CERTIFICATE OF APPROPRIATENESS PLACARD

606 N BOUNDARY STREET

009-14-MW

- Change previously approved COAs 176-13-MW and 008-13-CA:
- configuration of rear screened porch screening;
- relocate front walkway and steps to align with front steps of altered house;
- change front retaining wall material to brick;
- install storm door;
- change front gable from cedar shakes to horizontal siding;
- change porch railing design.

STORM DOORS

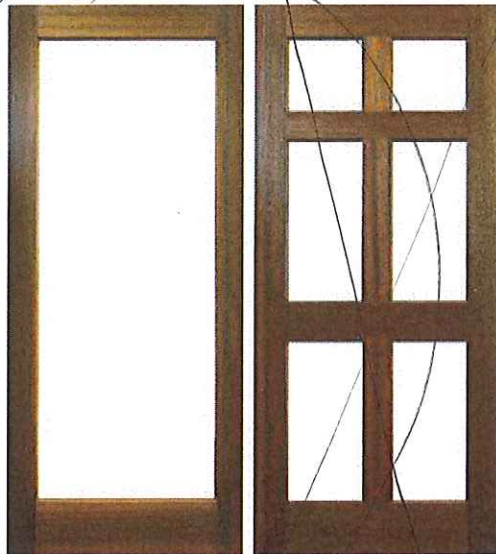
1. Current photos of the front of the house;
2. Specifications/details for the proposed tapered columns;
3. Storm door specifications;
4. Explanation of “brick construction ILO stone built off porch ILO ground” As stated in a previous email stone was never approved.

GLASS: Clear Bevel
TIMBER: Mahogany
DOOR: 36 1/4" x 84 1/4" x 1 1/8"

A1.0

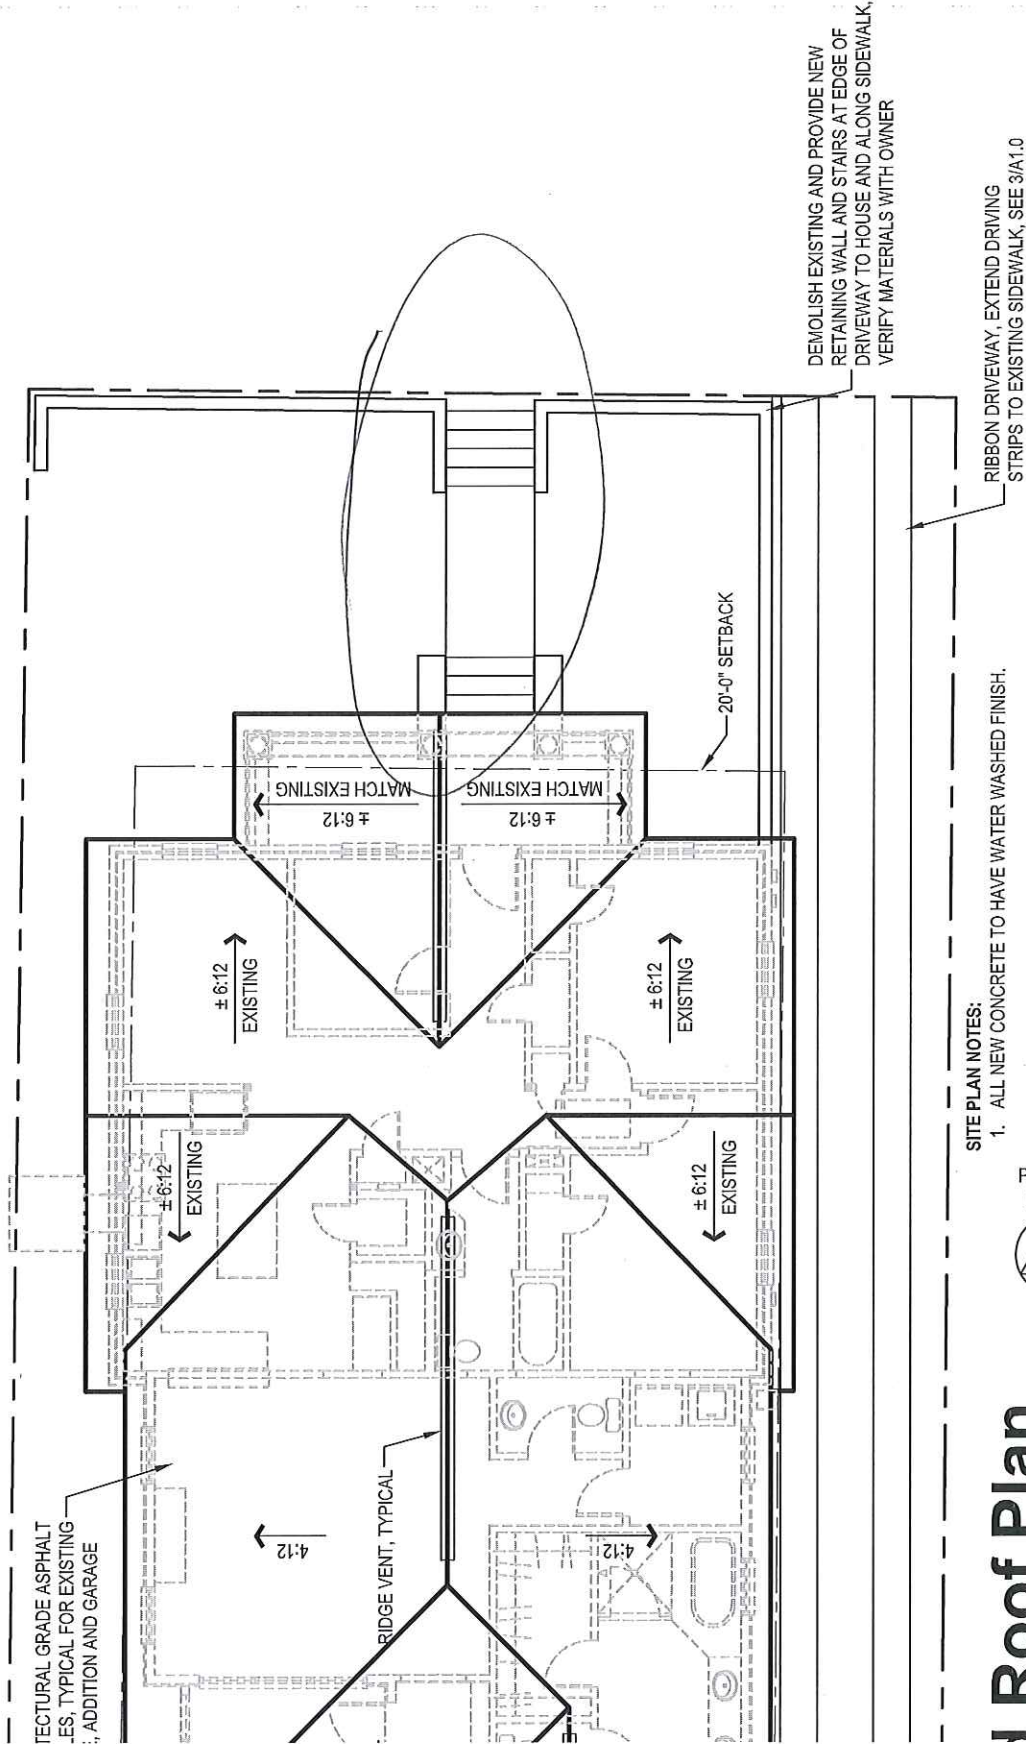
7.
Need a revised drawing (plan only is ok) showing the new location of the front sidewalk and steps. (photo references an attached sheet A.10 that was not included) Current drawing A1.0 shows front sidewalk location - site and roof plan view on bottom of drawing. **Drawing not included with application. Please send.**

7. Need a revised drawing (plan only is ok) showing the new location of the front sidewalk and steps. (photo references an attached sheet A.10 that was not included)

DEMOLISH EXISTING AND PROVIDE NEW RETAINING WALL AND STAIRS AT EDGE OF DRIVEWAY TO HOUSE AND ALONG SIDEWALK, VERIFY MATERIALS WITH OWNER

RIBBON DRIVEWAY, EXTEND DRIVING STRIPS TO EXISTING SIDEWALK, SEE 3/A1.0

Minor Work Pic's 009

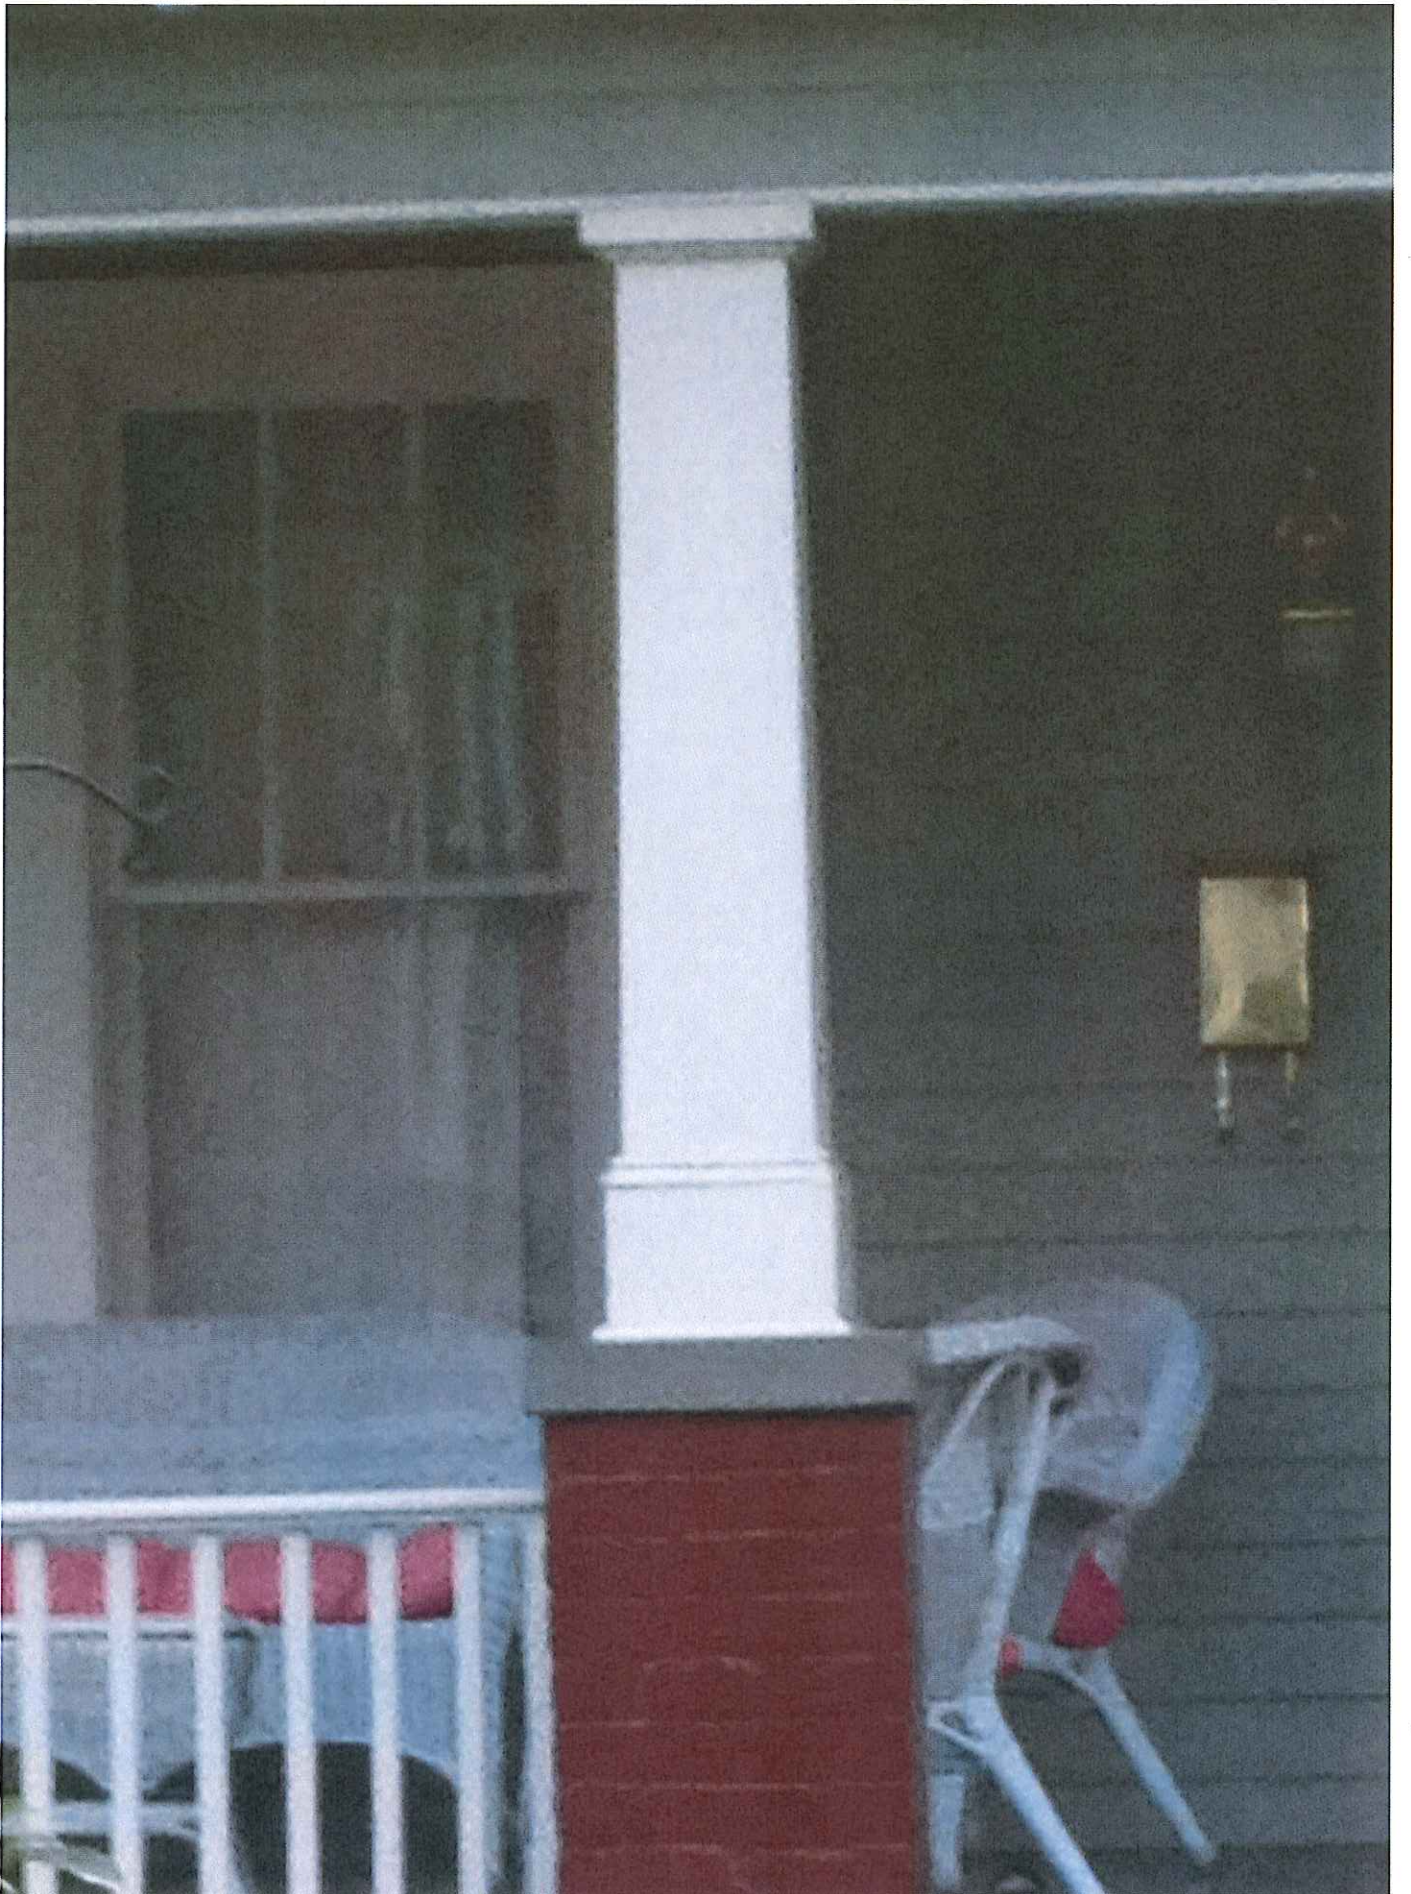
1.
Current photos of the front of the house; Photos will be forwarded in separate emails for current front of house and driveway views. **OK**
2.
Specifications/details for the proposed tapered columns; Will provide sketch/drawing in separate email **OK (not yet received)** — see photo 009
3.
Storm door specifications; Link attached in separate email and note framed glass door on shown on left of page **OK (not yet received)**
4.
Explanation of "brick construction ILO stone built off porch ILO ground" As stated in a previous email stone

TLB Picture 009 shows a similar tapered column that we will look to match. Tapered column will start at 15"x15" wide and extend 50" high.
